Addendum 3

East Coast Hearing and Balance
Morehead City, North Carolina

UTILITY PLAN

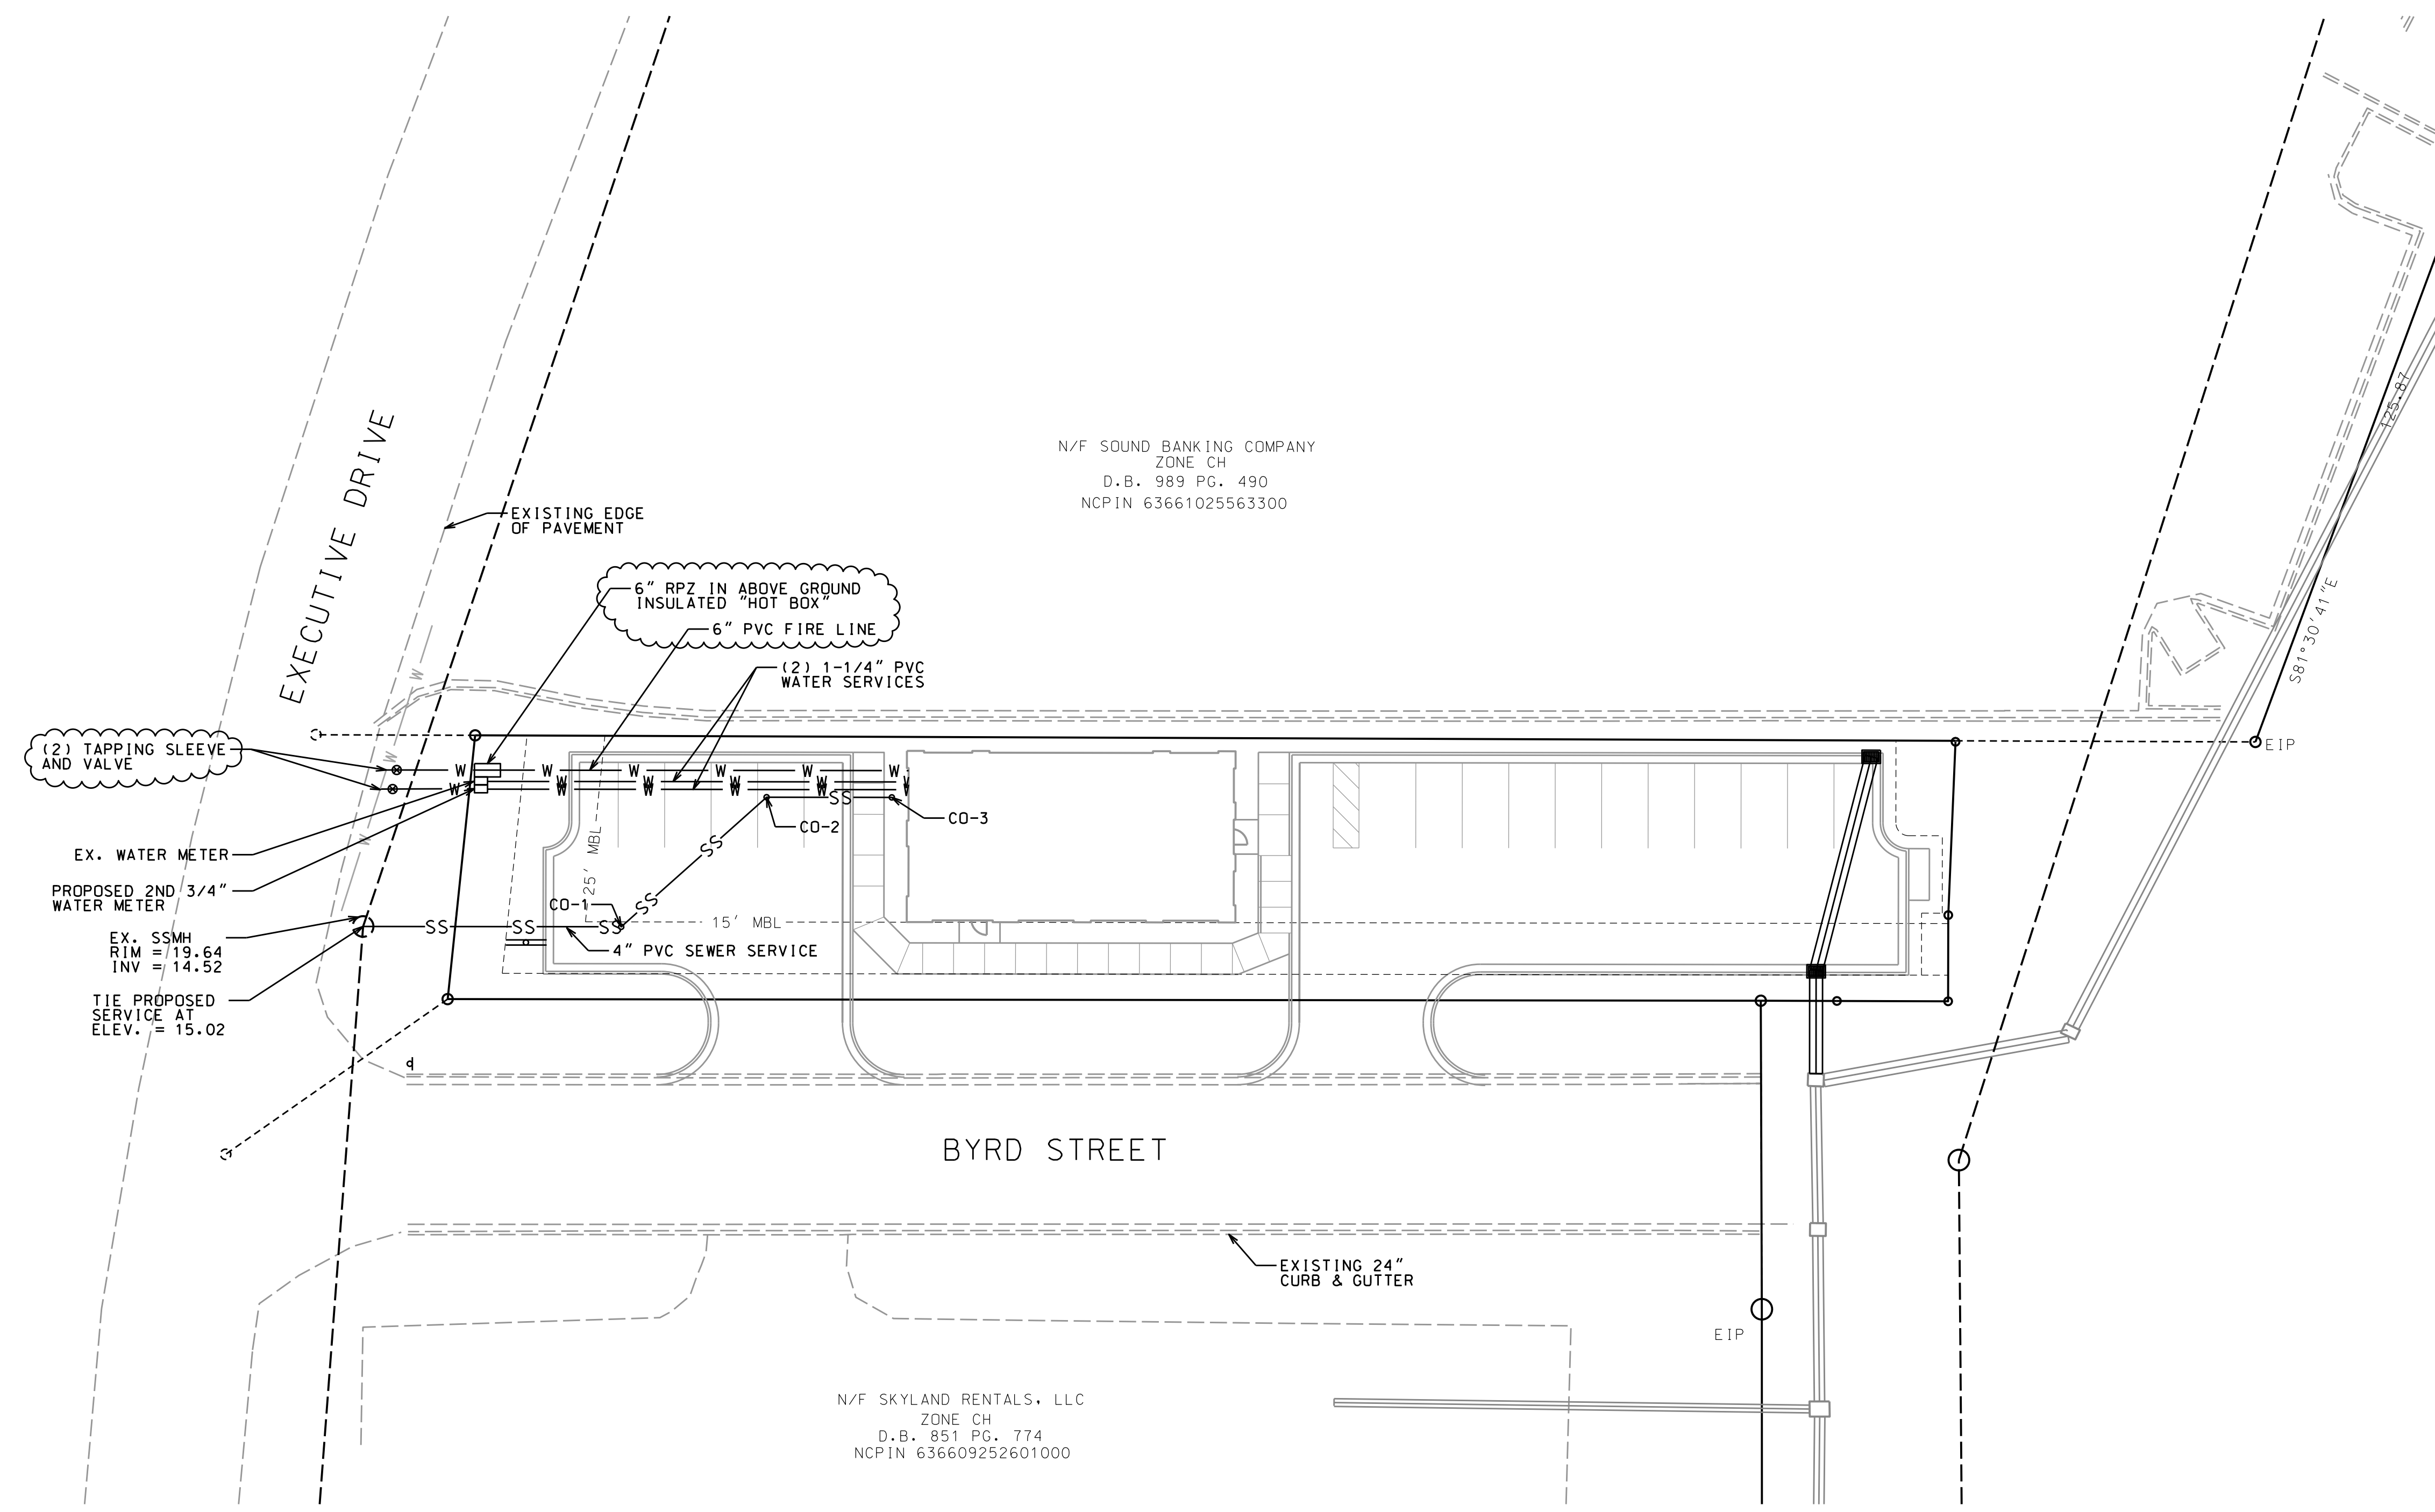
- The Bid Date has been revised to 20 November 2018 at 4pm.
- Base bid to include a full fire sprinkler system designed and installed by a NC Fire Sprinkler company. Sprinkler system to include water curtain sprinklers at all windows on rear wall. See attached revised Utility Plan with added 6" Fire Line, 6" RPZ Hotbox and tapping sleeve and valve. Provide electrical circuit to hotbox.

No.	BY	DATE	DESCRIPTION
1	CMC	11/5/18	ADD 6\"/>
